October 7, 1976
REGULATORY DOCKET FILE COPY

RE: Oconee Nuclear Station
Docket Nos. 50-269, -270, -287

KEOWEE OVERHEAD EMERGENCY POWER PATH
SEISMIC QUALIFICATION AND ANALYSIS
REQUEST FOR ADDITIONAL INFORMATION

Figure 1

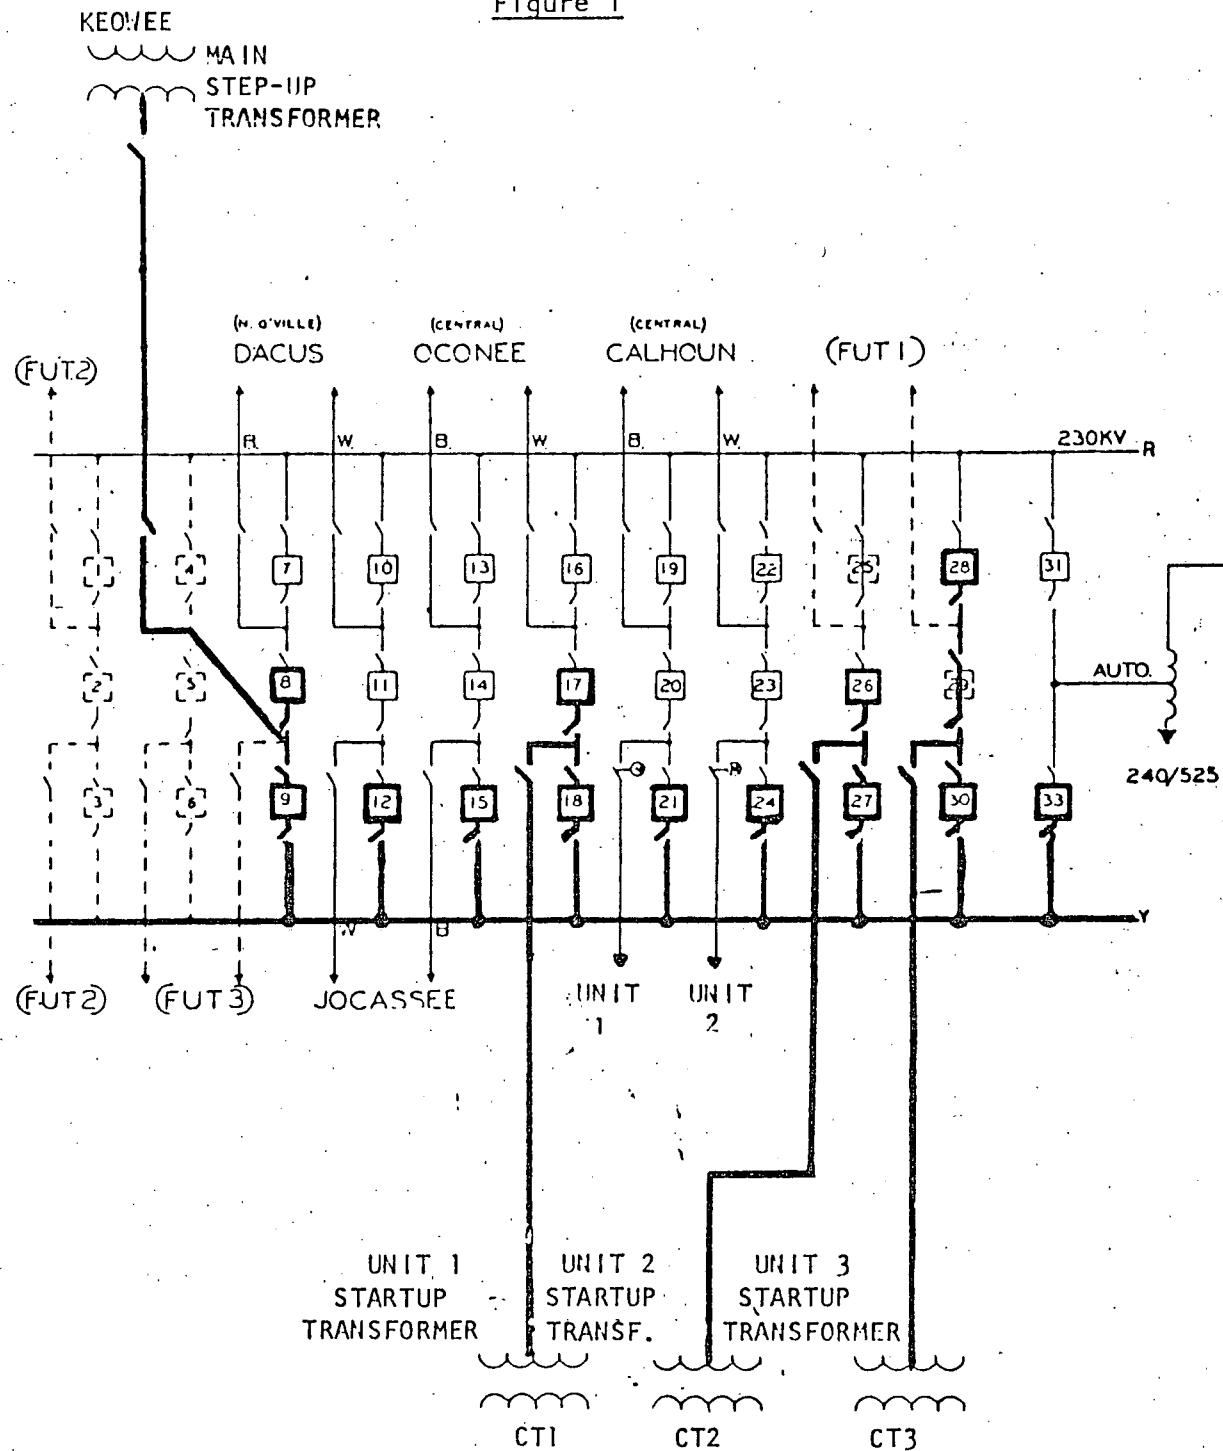
The Keowee Overhead Emergency Power Path is shown in bold lines on Figure I.
